**Response to Review Comments, Preliminary Subdivision & Site Plan Application: Cook Road Retirement Community**

We are pleased to provide the enclosed information in response to review comments from Town of Windham staff (Memo to Planning Board dated December 5, 2018 and Memo from Jon Earle Dated November 30, 2018), and to address comments raised at the Planning Board meeting on Monday, December 10. This submission also incorporates comments from staff on a draft submission that we provided via e-mail on December 17, 2018.

**From:** Jonathan R. Earle  
**Sent:** Friday, November 30, 2018 3:09 PM  
**To:** 'Jeff Amos, P.E. '; Amanda L. Lessard  
**Subject:** 18-31 Cook Road Retirement Community - Preliminary Plan Review Comments

| TITLE: NITRATE-NITROGEN ASSESSMENT SITE PLAN   |  | DRAWN BY: KRF        | DATE: DECEMBER 14, 2018 |

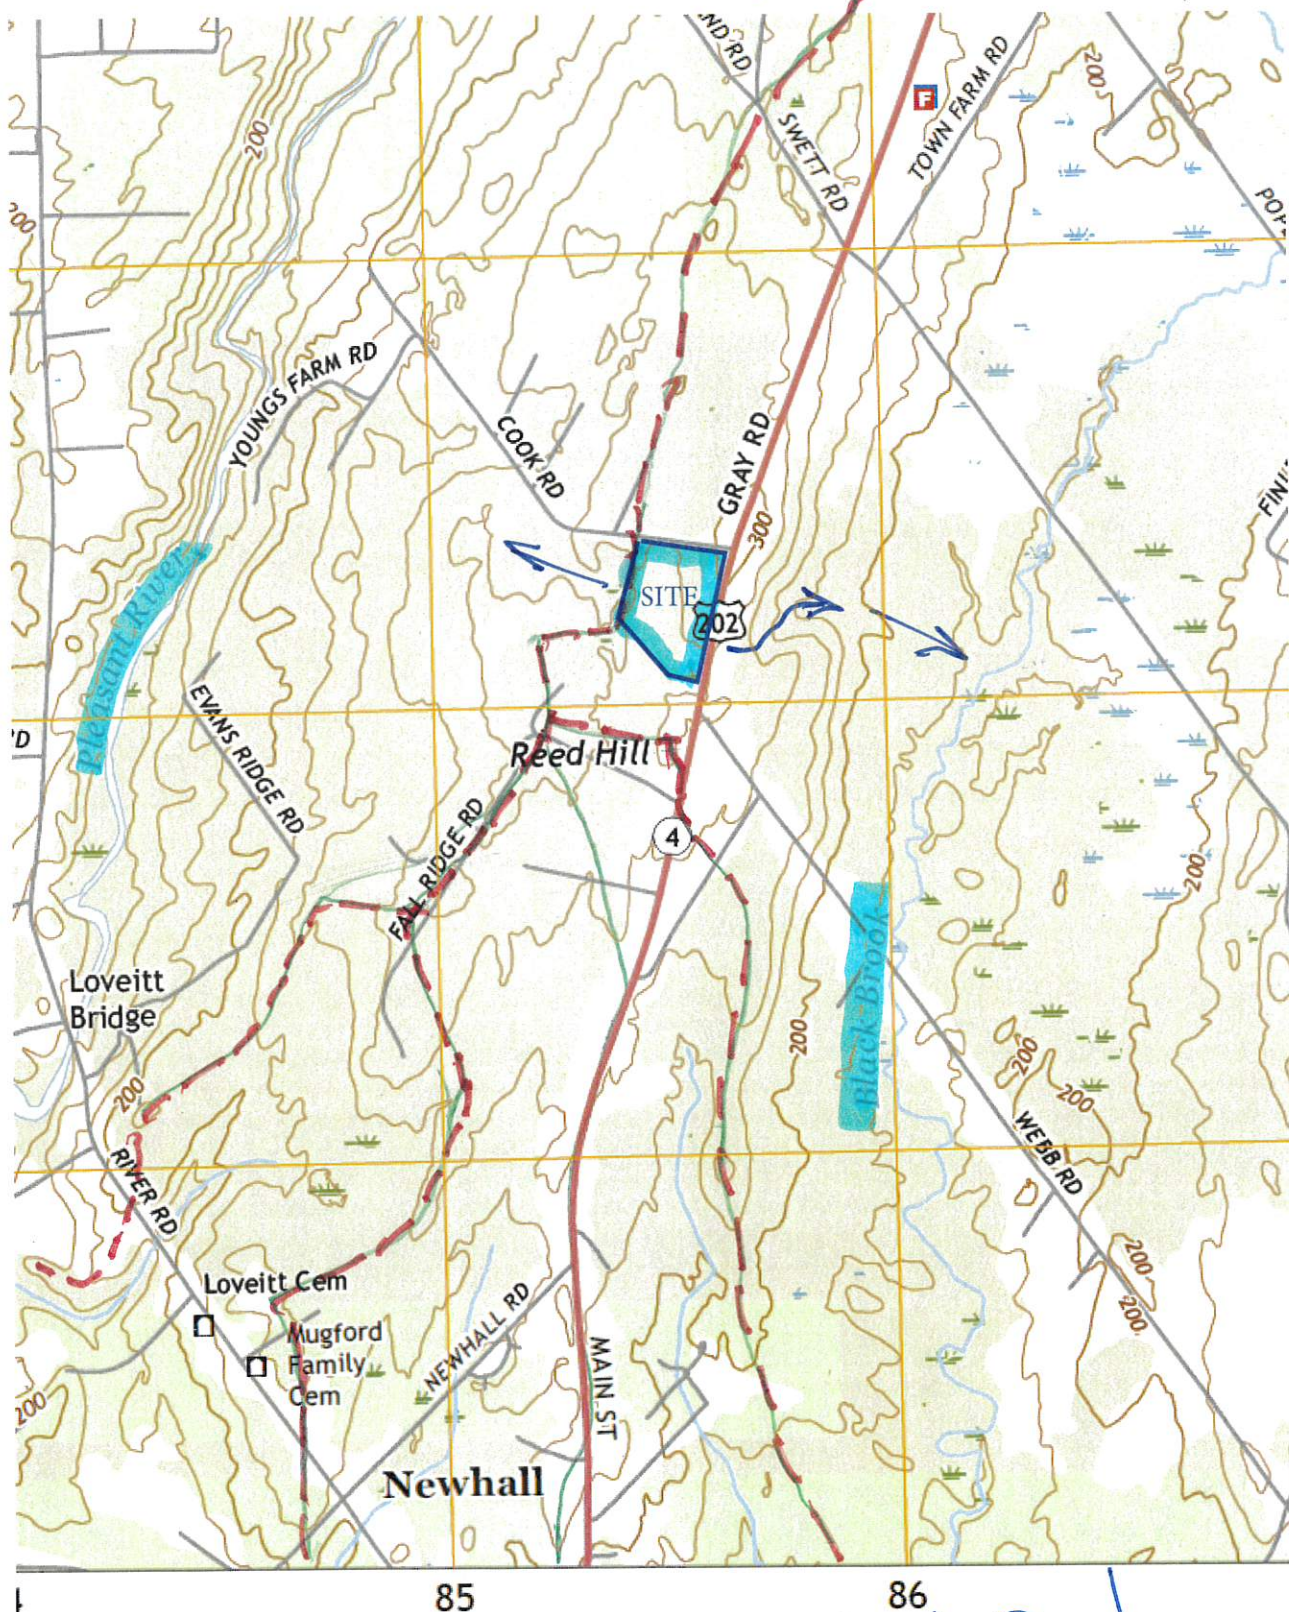
4. Will a plan be provided showing the nitrate plumes at each disposal field location. A statement from Steve Marcotte was provided which indicates that the nitrate discharge will be less than 10 mg/L at the property line, but a nitrate plume plan would be helpful in support of this criteria.

5. A nitrate plume plan is enclosed (Attachment 1).
6. Portland Water District reviewed the plans and provided comments, which have been incorporated on the Utility Plan. We are forwarding the revised plans to PWD for their review in providing the ability to serve letter.

***Submitted 12/17/2018***
